Access Compliance Report

Public Rights-of-Way

Intersection ID: 30298	Main Street: CHALLENGER_DR	Cross Street: METROLINER_CT	Location:	N
ADA ID: 417BEA0BA037	Ramp Type: BlendTrans1	Initial Pass/Fail: Pass	Overall Compliance: No	Severity Score: 17.75
Codes/Mitigation Info/Possible Solution		Field Measurements/Component Compliance

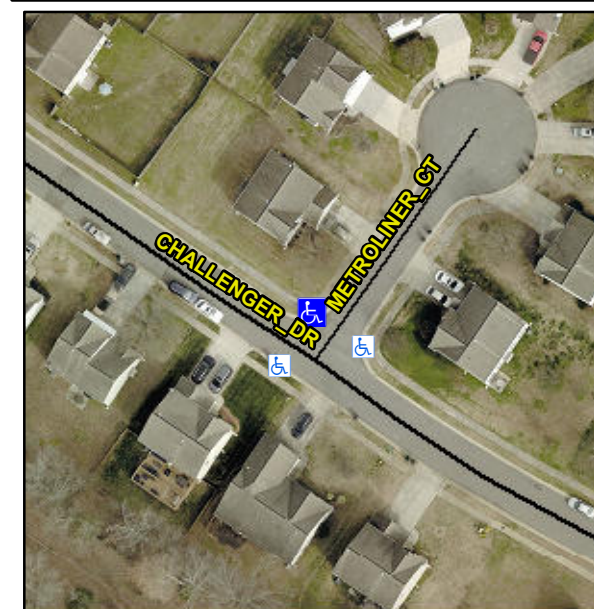
Not Found, R304.5.3, R305, R302.7.2

Compliance	Description	Data	Compliance	Description	Data
N/A	Ramp Length (in)	46.5	Yes	BlendTrans Slope (%)	3.0
Yes	Ramp Width (in)	48.5	No	BlendTrans XSlope (%)	3.8
N/A	Flare Type LT	Sloped	N/A	Flare Type RT	Sloped
N/A	Flare Slope LT (%)	5.3	N/A	Flare Slope RT (%)	3.1
N/A	Flare Traversable LT?	No	N/A	Flare Traversable RT?	No
Yes	Landing Length (in)	48.0	No	DWS Provided?	No
Yes	Landing Width (in)	48.0	N/A	DWS Contrast?	No
Yes	Landing Slope (%)	1.2	N/A	DWS Length (in)	N/A
No	Landing X Slope (%)	6.5	N/A	DWS Full Width?	No
N/A	Landing Curb? (Y/N)	No	N/A	DWS Offset (in)	N/A
N/A	Shared Landing?	No			
Yes	Gutter Ponding?	No	Yes	Gutter Slope (%)	1.1
No	Gutter Lip Ht (in)	0.3	No	Gutter X Slope (%)	6.4
N/A	Painted X Walk1?	No	N/A	Painted X Walk2?	No
	X Walk 1 Direction	To SW		X Walk 2 Direction	To SE
	X Walk 1 Width (in)	N/A		X Walk 2 Width (in)	N/A
	X Walk 1 Slope (%)	5.5		X Walk 2 Slope (%)	1.1
	X Walk 1 X Slope (%)	2.0		X Walk 2 X Slope (%)	6.7

N/A	Ramp inside XWalk1?	N/A	N/A	Ramp inside XWalk2?	N/A
	Road Slope (%)	6.6		Clear Space?	Yes
	Road X Slope (%)	5.9	N/A	Clear Space to XWalk (in)	N/A
Yes	Any Obstructions?	No	Yes	Storm Grate/Utility Hazard?	No
	Obstruction Type			Storm Grate/Utility Type	
		N/A			N/A
			Yes	Surface Condition? (G/P)	Good
			No	Curb Slope (%)	19.4

Remove & Replace Curb Ramp With Two New Directional Ramps or Equivalent. Remove & Replace Gutter.
